TRANS/WP.29/GRSP/2003/16  
24 September 2003

**PROPOSAL FOR DRAFT AMENDMENTS TO REGULATION No. 16**  
(Safety-belts)

Transmitted by the expert from France

Note: The text reproduced below was prepared by the expert from France in order to authorize the use of an acceleration test device for validation of the dynamic behaviour of a safety-belt.

"Annex 8

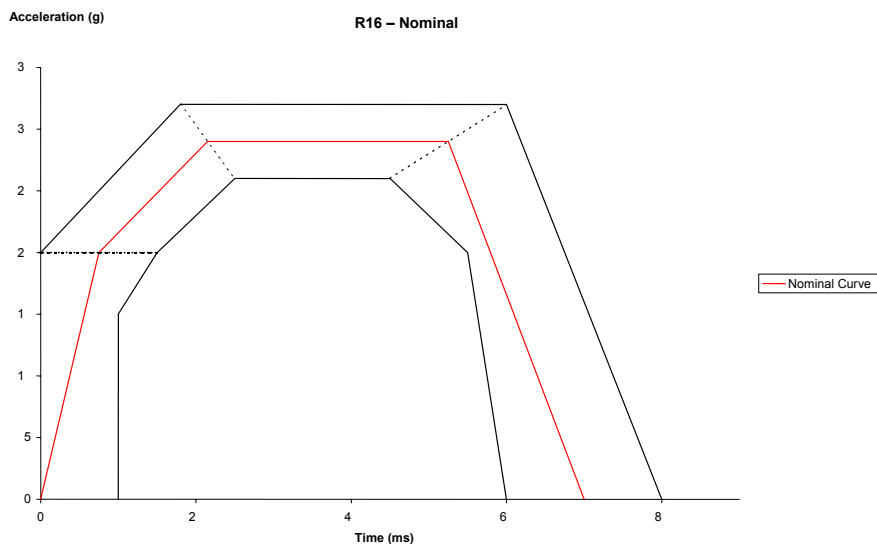
Annex 8, amend to read:

DESCRIPTION OF CURVE OF TROLLEY' S DECELERATION (ACCELERATION)  
AS FUNCTION OF TIME

Definition of the nominal curve

Parts of annex 8 have been put in paragraph 7.7.4. in order to use the same annex 8 for the two test devices (acceleration and deceleration).

As it can be seen in the table below the actual pulse corridor permits a wide range of variation of speed if there is no defined impact speed.

It is for that reason that a variation of speed of 56 km/h has been defined for the acceleration test device. This variation of speed corresponds to nominal curve and also to actual variation of speed on deceleration test devices including impact speed plus rebound speed.
